ZONING BOARD OF APPEALS APPLICATION

Project Name, If Applicable: Ungvary Residence

PLAN REVIEW COMMENTS

APPLICATION NUMB: ALT 054-21
DATE RECEIVED: March 24, 2021
LOCATION: 5 Sycamore Street
SBL: 24./2/6.A
APPLICANT NAME: JDS Custom Homes Inc.
APPLICANT ADDRESS: 11 Park Avenue Terrace
Yonkers, NY 10703

SITE PLAN
1"=20'-0"

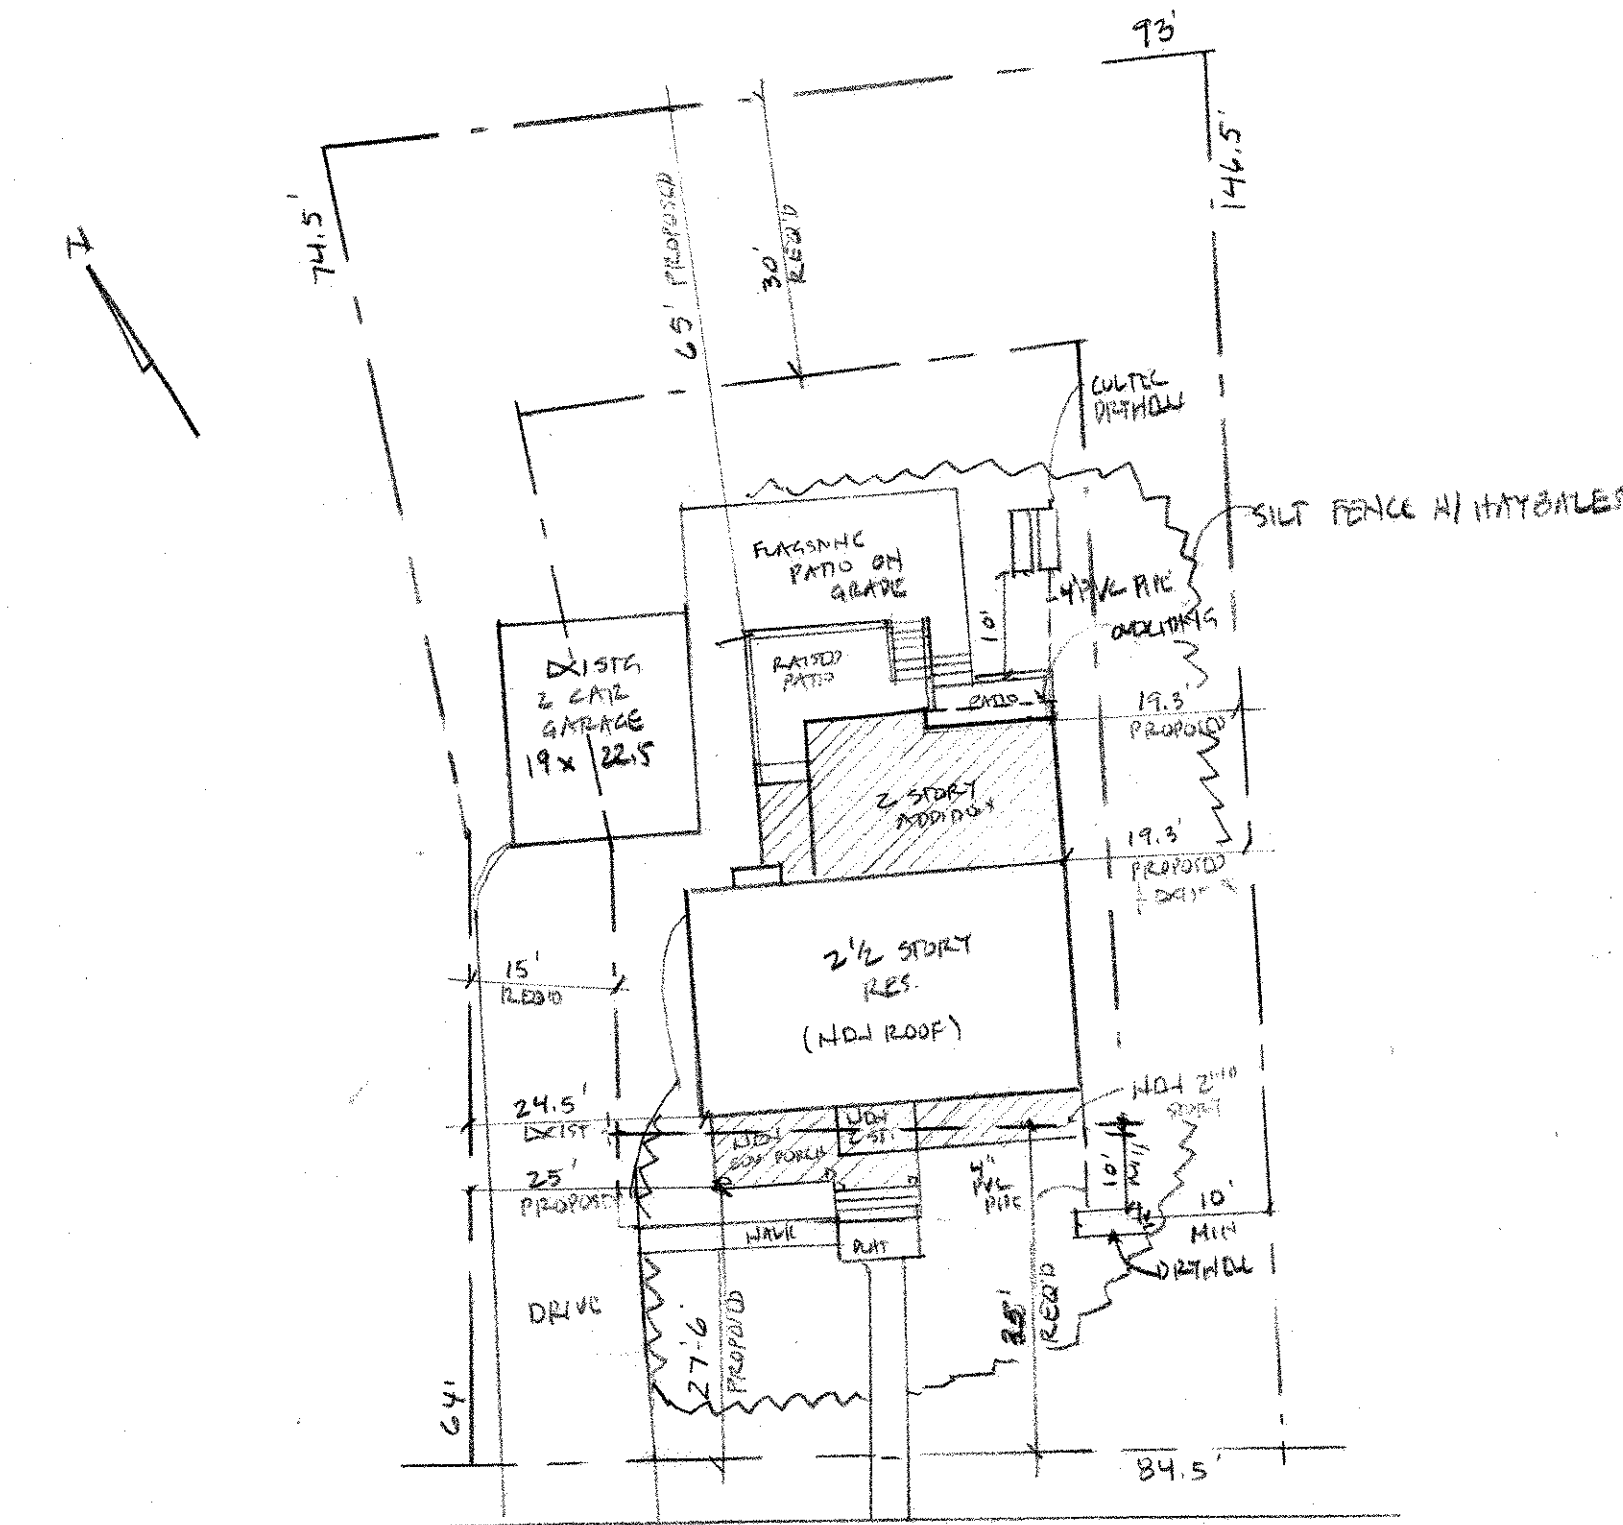
- 1) Front Yard Setback - Min 35ft, proposed 27.5ft; variance requested 7.5'
- 2) FAR Increase >30% - Existing - .155; proposed .240; 30% of .155= .0465; .155+.0465=.2015 max FAR - referral to planning required
